DESCRIPTIVE REPORT

Registry No. H11369

General Locality Behm Canal

Project OPR-O193-FA

Figure 3. CARIS 2D Subset comparison of survey H11335 (beige) and H11369 (red).

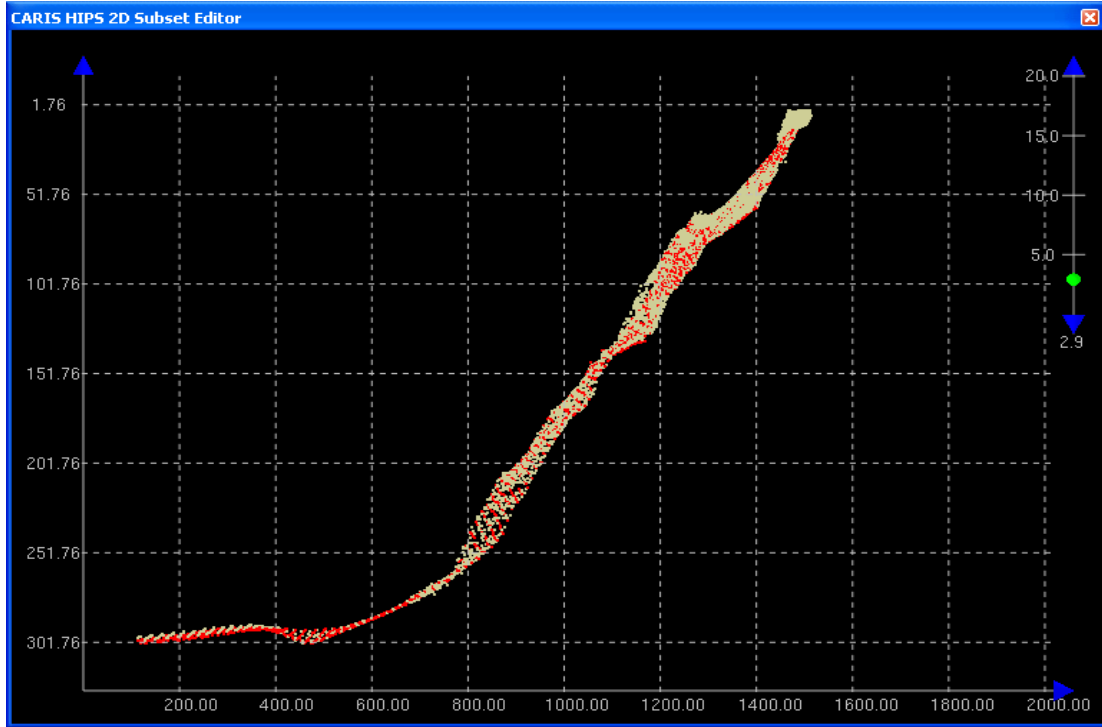
Survey H11369 junctions with survey H11335 to the north. Through manual examination of the data in CARIS subset mode, the hydrographer has determined that there is good agreement between survey H11335 and survey H11369⁴.

⁴ Concur

Figure 5. Chart 17420 rock.

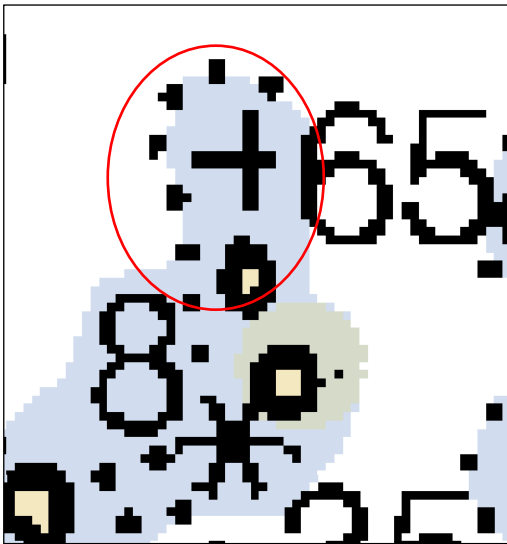
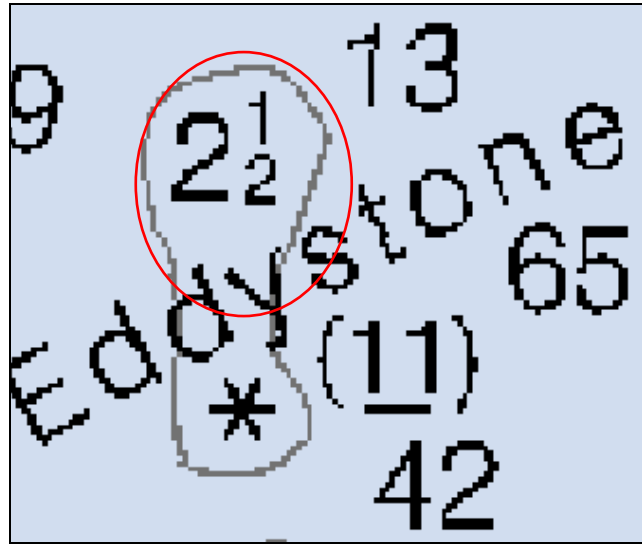
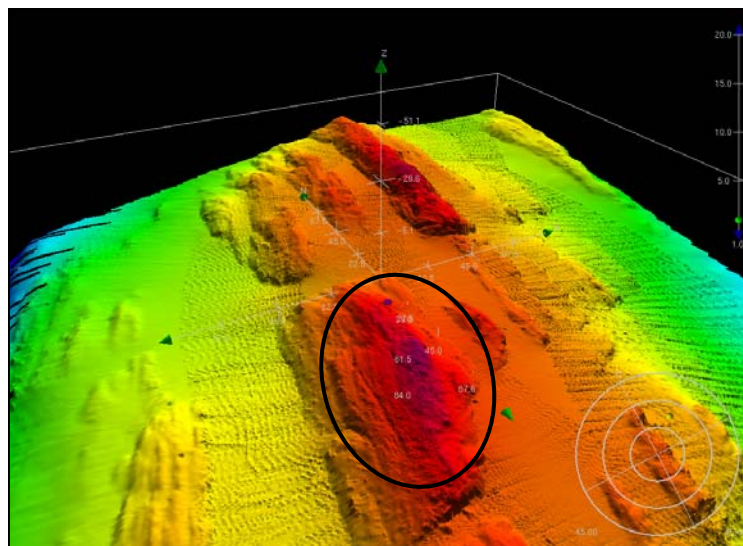
The charted Dangerous Underwater Rock with Uncertain Depth west of the 65 fathom sounding in New Eddystone Islands was not found. It is an extension of a shoal in that area. It is correct as depicted on chart 17424 (see figures 5, 6 and 7).

The 65 fathom sounding in New Eddystone Islands is not the controlling depth of that area. The hydrographer feels that the 13 fathom sounding as shown on chart 17424 is a better representation of the bottom (see figures 5 and 6)¹³.

¹³ Concur, chart the area as shown in the HCell

Figure 8. CARIS 3D Subset view of New Eddystone Islands DTONs.

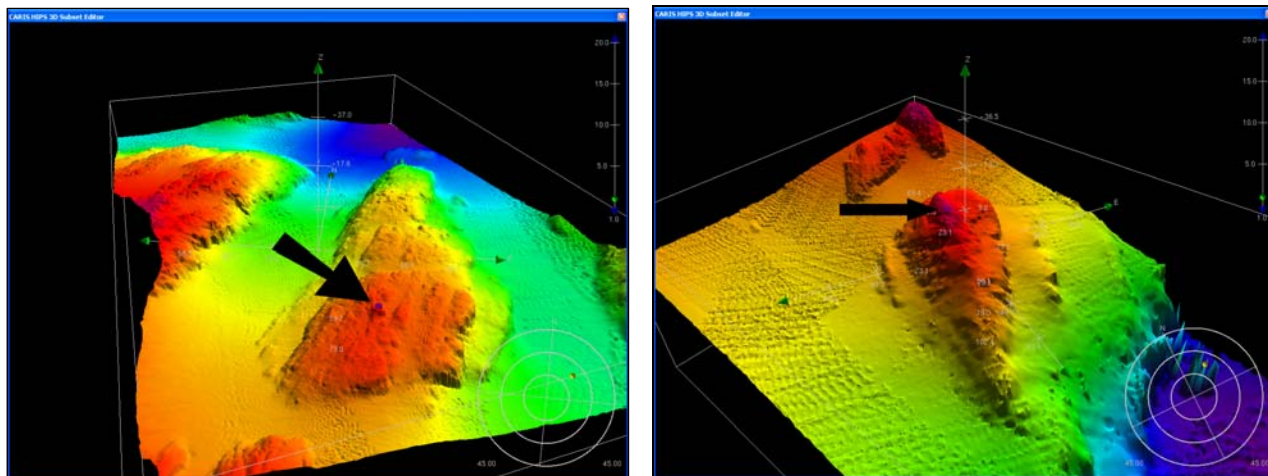
There are two areas of shoaling approximately 340 meters apart in a small passage between two islands on the west end of New Eddystone Islands. These areas are approximately 5

fathoms shoaler than charted. Both were submitted as dangers to navigation because crab fishermen were seen transiting this passage on a daily basis during survey operations.

¹⁹ The DtoNs were designated during the Survey Acceptance Review and one was compiled to the HCell. DtoN 866/76 was not compiled to the HCell because of a shoaler sounding in the area.

Figure 1.1.1 CARIS 3D Subset view of 5.25 fathom shoal.

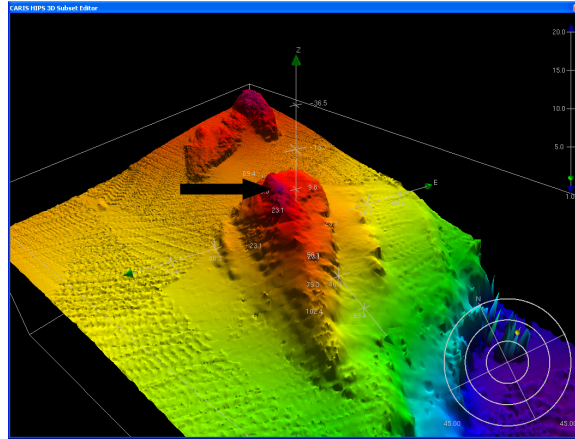
5.25 fathom sounding. Charted (17424) 11 fathoms. Area is transited by local crab fishermen on a regular basis.

Change charted (17424) 11 fathom sounding to 5.25 fathoms. Submit as Danger to Navigation to MCD.

Chart sounding.

Figure 1.2.1 CARIS 3D Subset view of 4.86 fathom shoal.

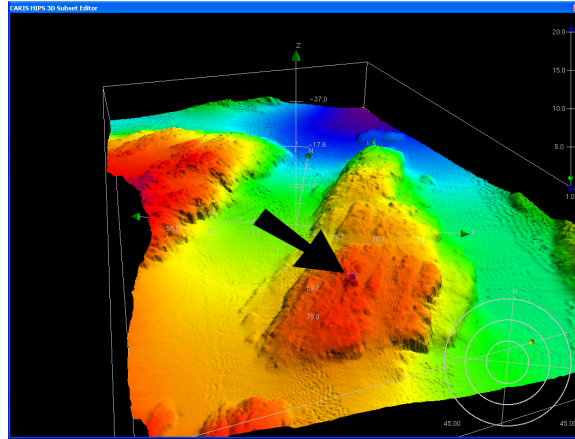
4.86 fathom sounding between 8 and 9 fathom charted (17424) soundings. Area is transited by local crab fishermen on a regular basis.

Change charted (17424) 9 fathom sounding to 4.75 fathoms. Submit as Danger to Navigation to MCD.

Chart sounding.

Figure 1.1.1 CARIS 2D Subset view of charted mooring buoy.

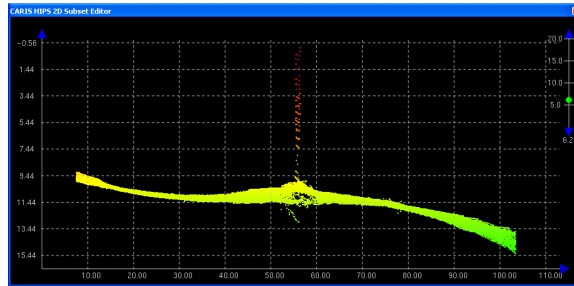
23111 Blue and white mooring buoy. New position of CHD mooring buoy.

Rechart charted mooring buoy at location 55°30'03.614" N, 130°59'18.844" W.

Chart new mooring buoy.
